US 74 Shelby Bypass

STIP Project R-2707D/E

Merger Team Update

January 24, 2018

Figure 2A

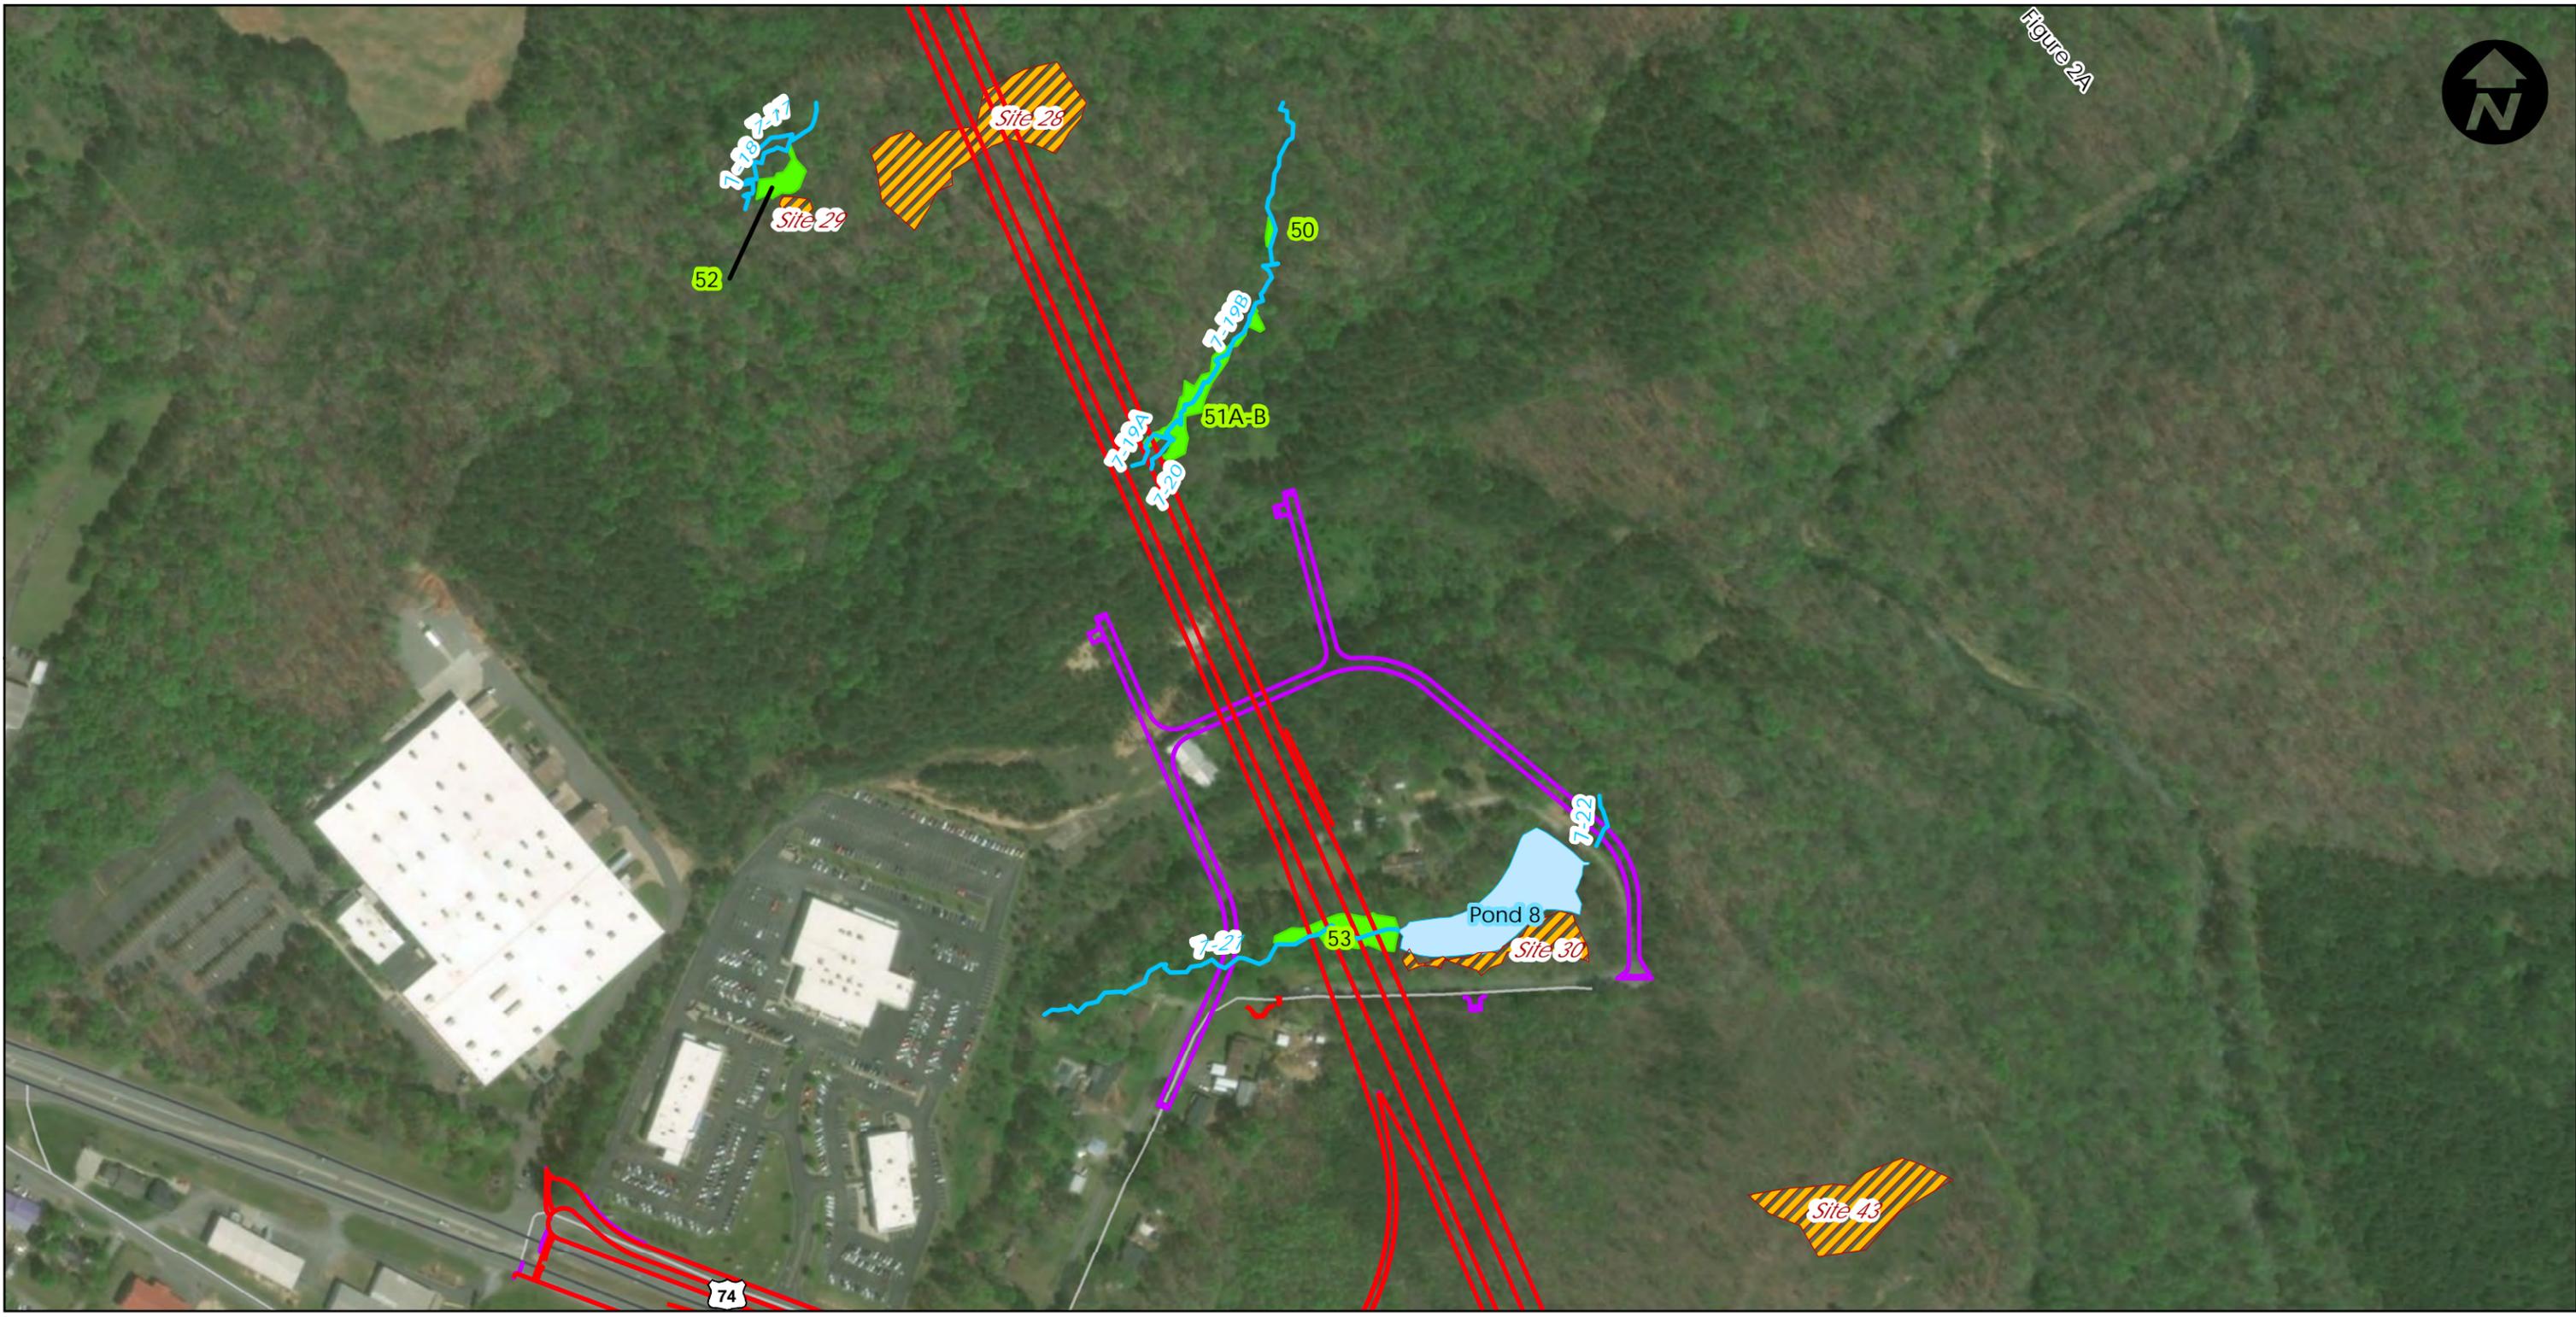
2017 Design Revisions:

Service Roads

New service roads were added to provide access to properties that are being isolated due to the construction of the Shelby Bypass as follows:

- Service Road 4: 1,020-foot long, 2-lane roadway connecting isolated parcels south of proposed Shelby Bypass to SR 2128 (Johnson Road).
- Service Road 5: 1,300-foot long, 2-lane roadway connecting to the disconnected section of Johnson Road. Dual 105-foot long, 2-lane bridges will carry the Shelby Bypass over Service Road 5.
- Service Road 5A: 350-foot long, 2-lane roadway connecting isolated parcels to Service Road 5.

Project Location	Cleveland County
Client/Project	NCDOT Division 12 STIP Project R-2707D/E 2017 Merger Team Update
Figure No.	2B

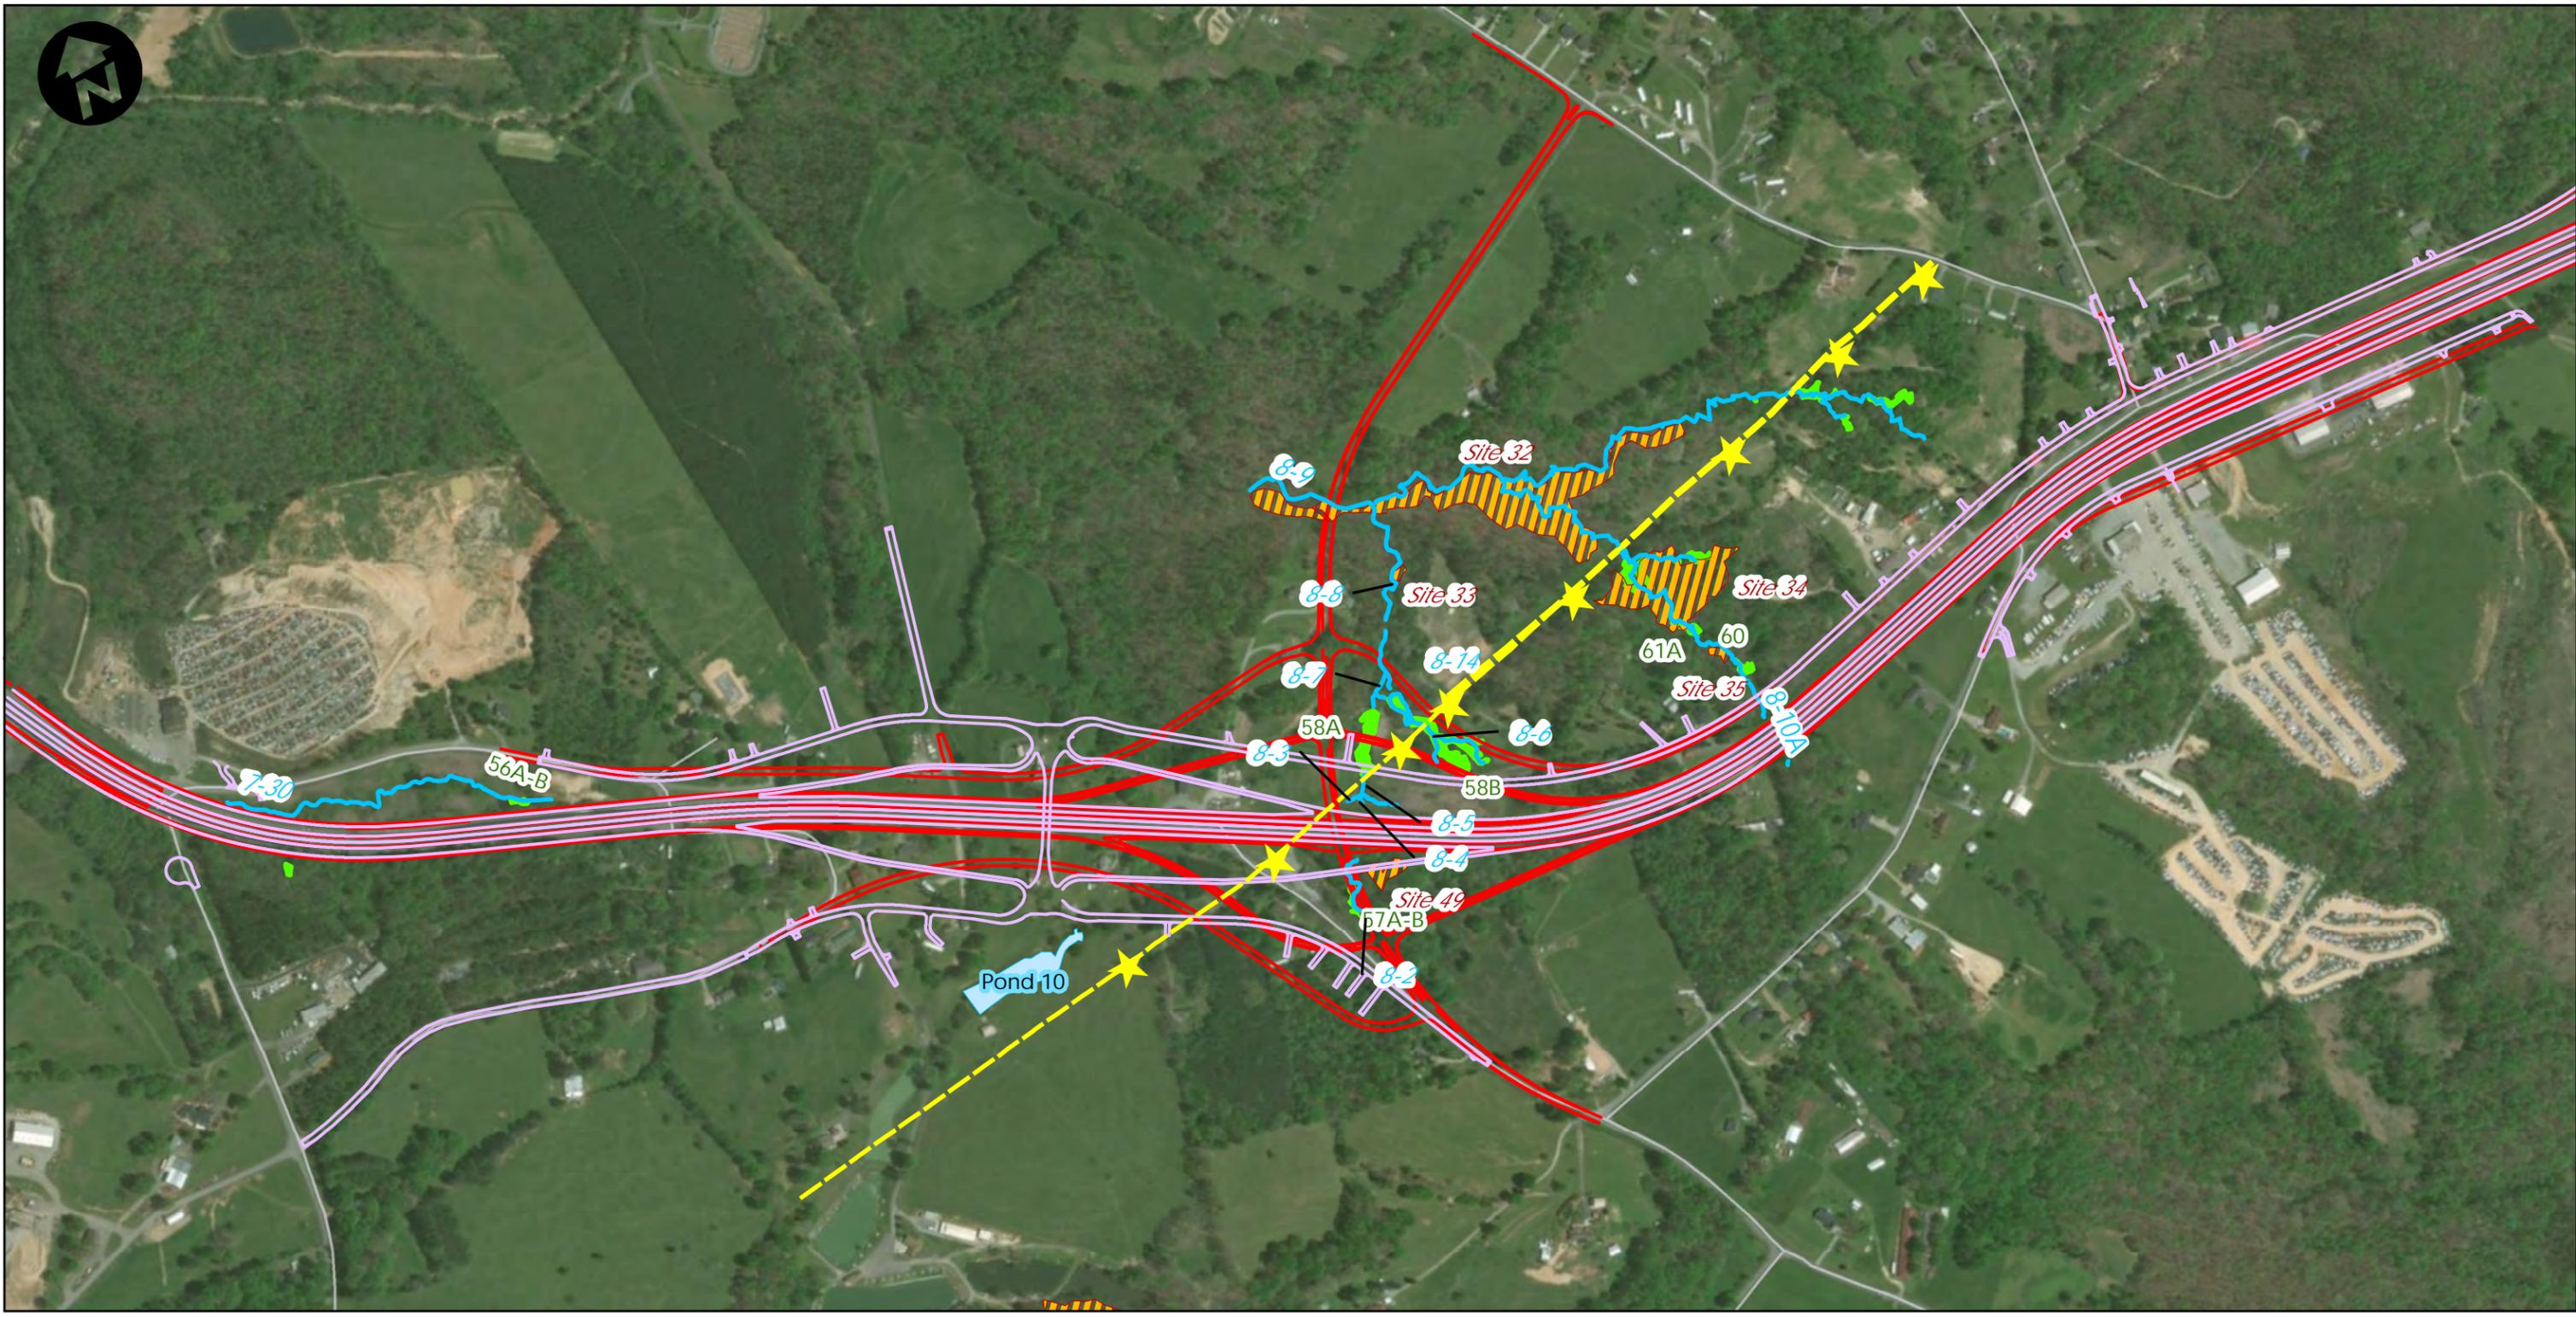
2017 Design Revisions:

Interchanges

- A modified diamond interchange with roundabouts is proposed west of the current US 74/Bethlehem Road intersection. The revised interchange is located approximately 1,100-feet west of the original interchange. The original interchange was moved due to the presence of a high transmission power line. Construction under the power line is not feasible and movement of the line would be extremely costly and would require significant construction time since the power line would have to be completed prior to construction of the bypass. The decision to move the interchange west resulted in a reduction in wetland and stream impacts.

Service Roads

Service road designs have been updated to accommodate the new interchange location and configuration.

- Service Road 6: 2,120-foot long, 2-lane roadway connecting Anthony Farm Road and Midway Lake Road to the proposed US 74/Bethlehem Road interchange.
- Service Road 7: 6,950-foot long, 2-lane roadway connecting Baptist Church Road to the proposed US 74/Bethlehem Road interchange.
- Service Road 8: 2,580-foot long, 2-lane roadway connecting isolated parcels south of US 74 to SR 2244 (Harmon Road).
- Service Road 9 (formerly part of service road 10): 1,160-foot long, 2-lane roadway connecting Anthony Road and Midway Lake Road to the proposed US 74 interchange.
- Service Road 9A: paving and widening an existing 1,900-foot gravel section of Anthony Road from Long Branch Road to Service Road 9.
- Service Road 10: 1,850-foot long realignment of Bethlehem Road is proposed to tie in to the proposed relocated interchange. The Bethlehem Road extension is no longer proposed.

Project Location	Cleveland County
Client/Project	NCDOT Division 12 STIP Project R-2707D/E 2017 Merger Team Update
Figure No.	3
Title	DFHL Survey Areas

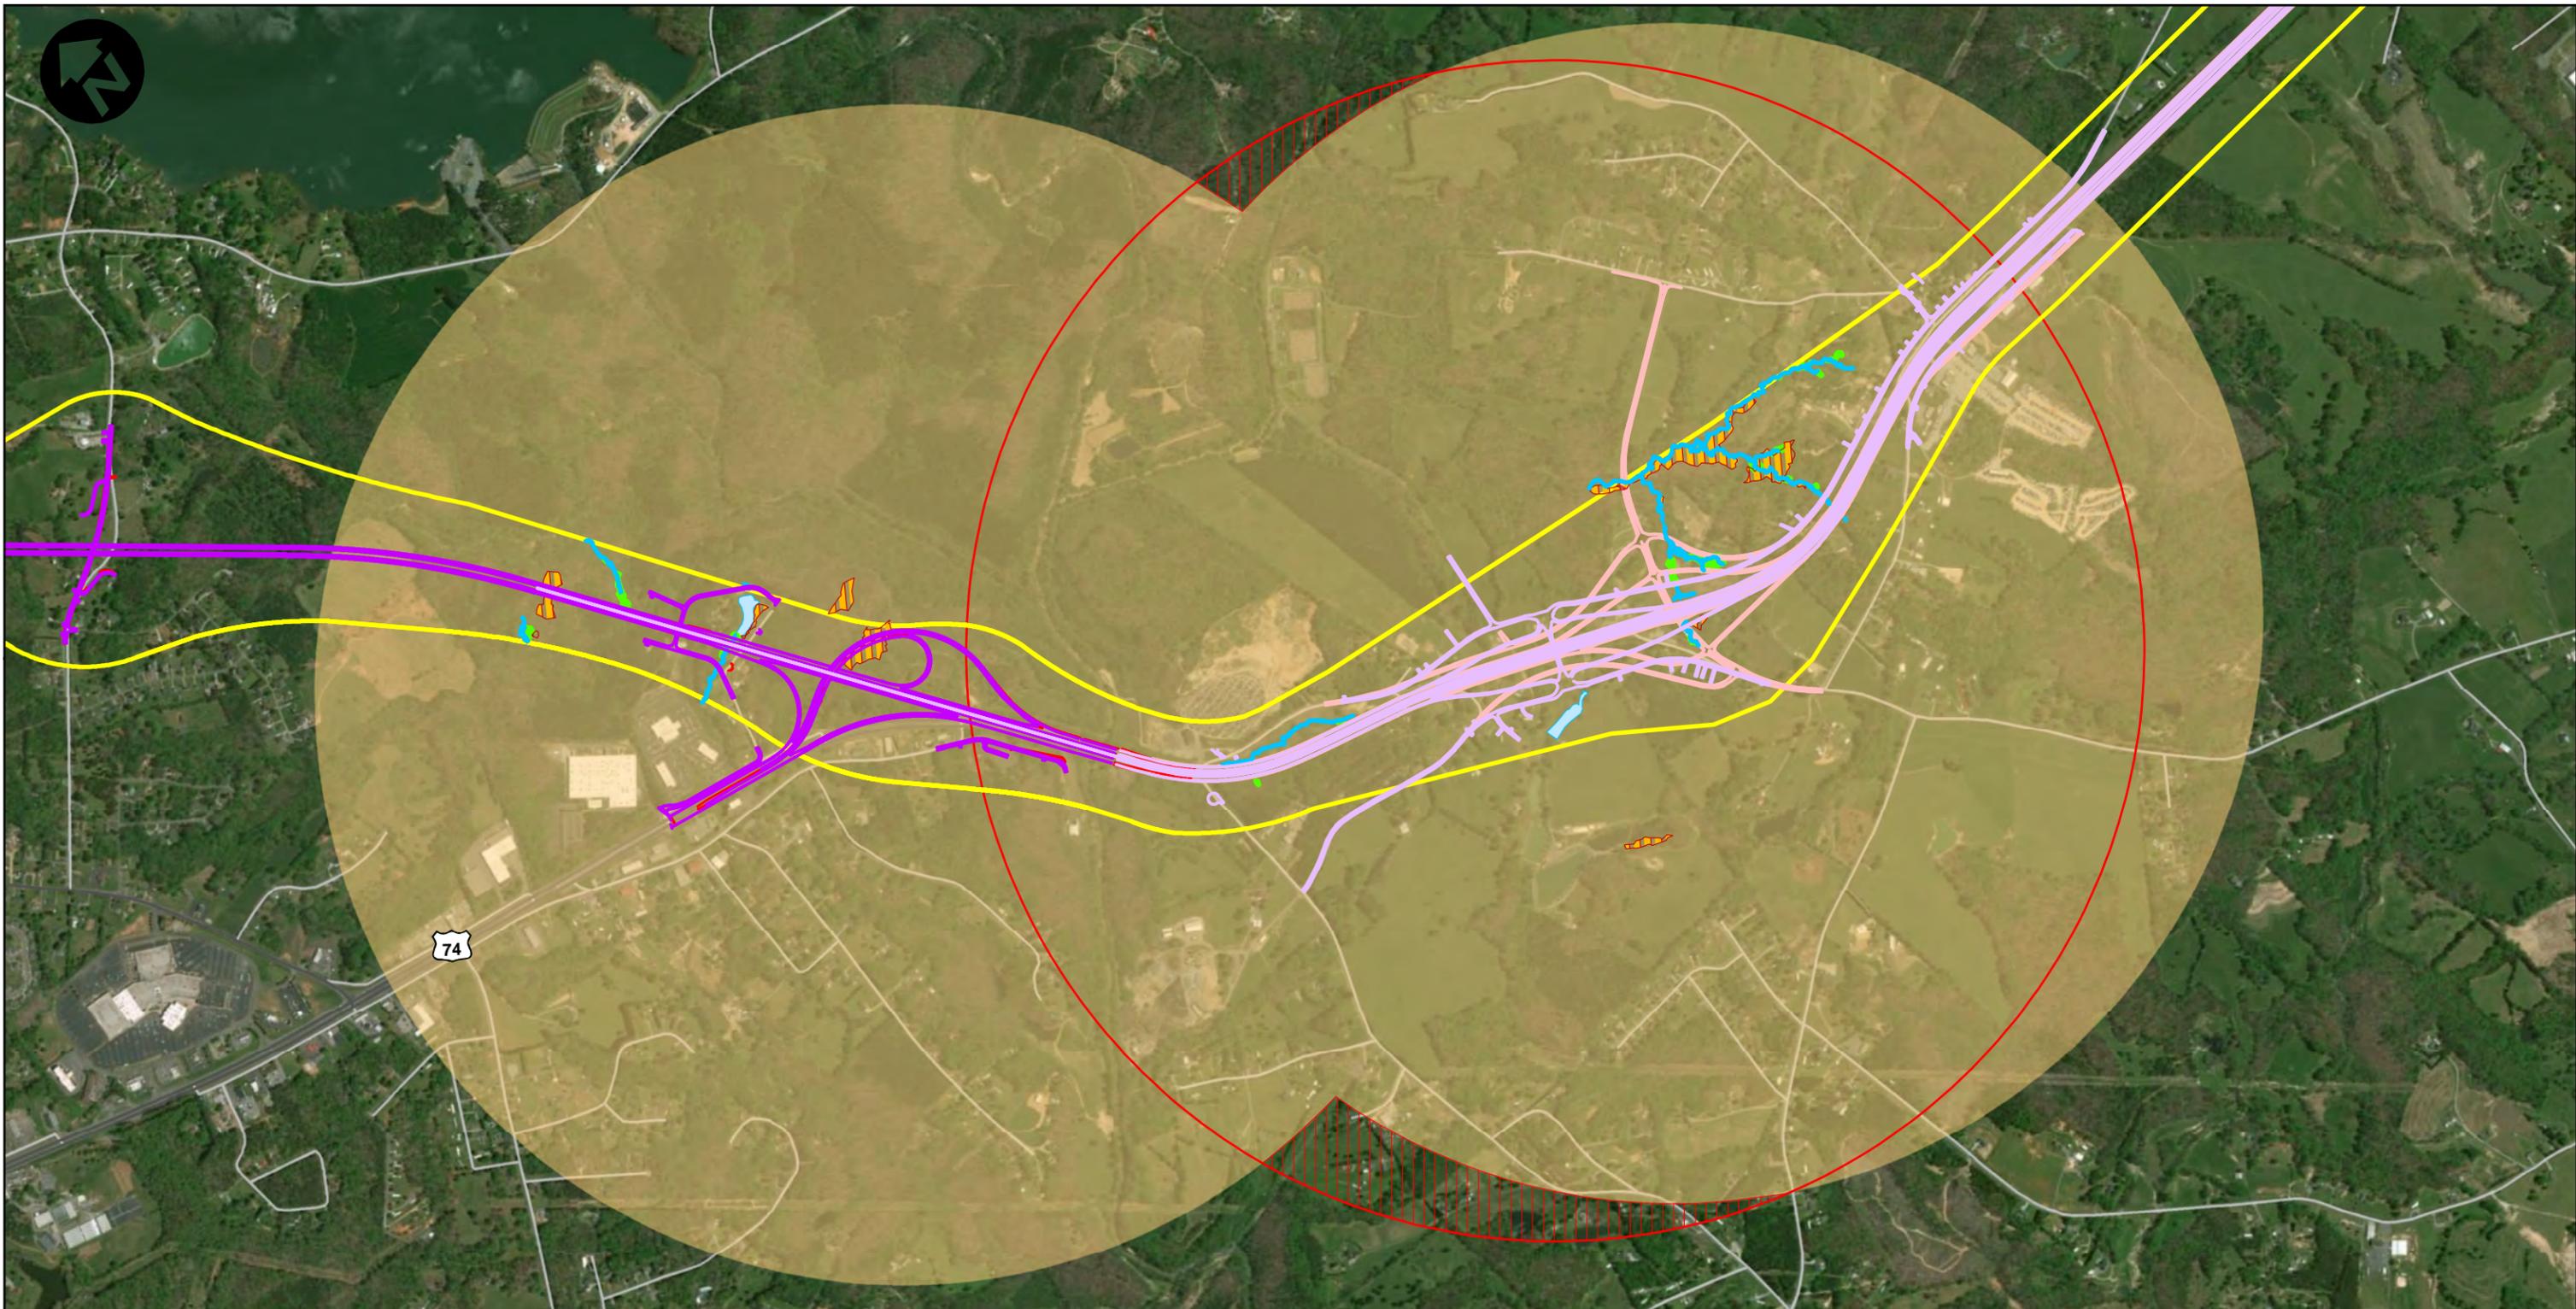
Design changes have eliminated the ability to preserve Site 32 within the ROW. Finally, the interchange redesign necessitates an additional survey for DFHL along a portion of the new interchange to determine the potential indirect and cumulative effects of the redesign (Figure 3).
